### GLASS PANEL SLIGHTLY DROPS DOWN AFFECTING HOOD ON/OFF SWITCH

#### DESCRIPTION

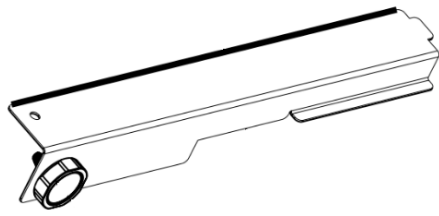
The glass panel drifts down and does not close well, affecting hood on/off switch (light and fan are on even in closed panel position).

Plastic material of the component inside Sklock mechanism is not able to withstand the glass panel weight in cooking conditions (high humidity & temperature) and deforms over time.

RIGHT

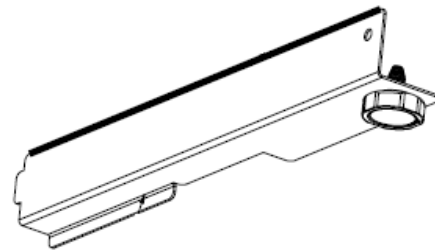
Introduction of magnet and gasket on the side covers, left and right (see images below).

*(before, after)*

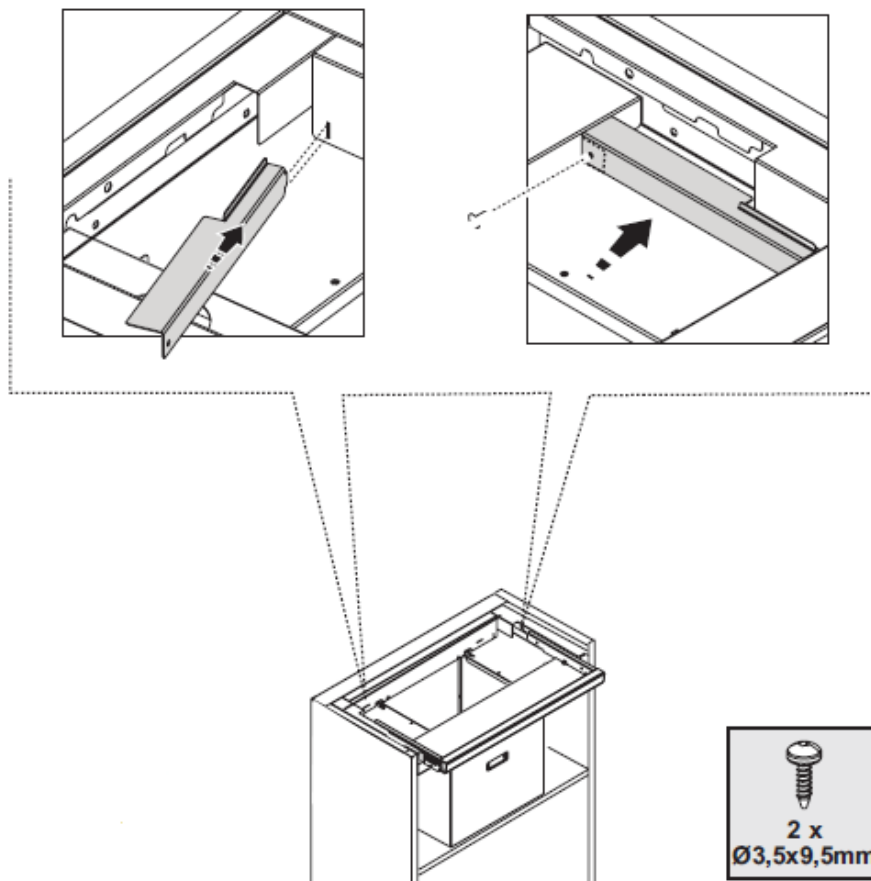
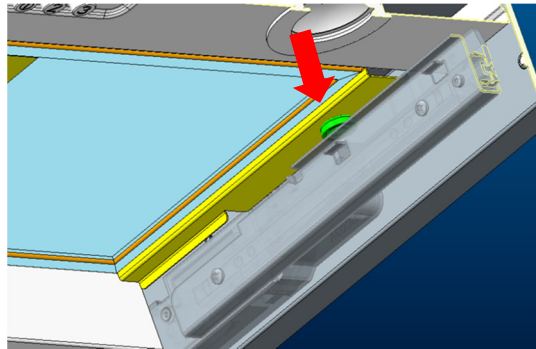
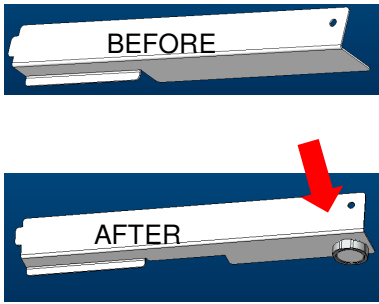
- Check in user inserted side covers provided in hood package during installation.
- If the side covers are inserted, replace them with side covers with magnet and gasket (included in kit 4055388914) according to pictures below.

- If side covers are not inserted, insert side covers with magnet and gasket (included in kit 4055388914) like in the picture above.
